Development Review Division

Community Development Department: *Town Hall / 20120 East Mainstreet Parker, CO 80138* Phone: 303.841.2332 Fax: 303.841.3223

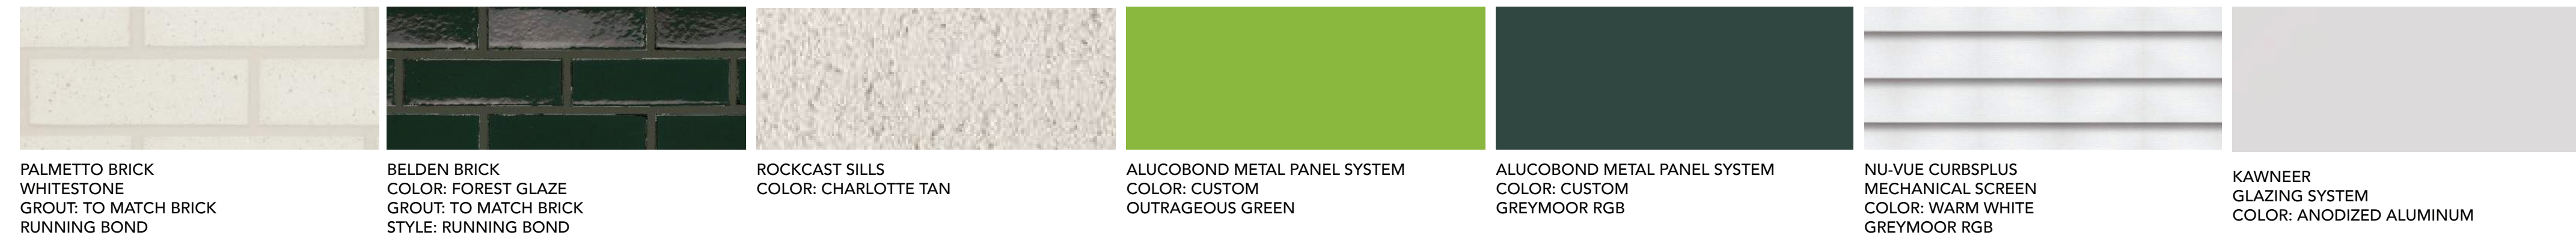
Vocon: Elevations have been revised to be broken up into a more pronounced top, middle, and base. The green glazed brick is proposed as a feature material used only at banking service locations (teller line, cash room, and drive-through services).
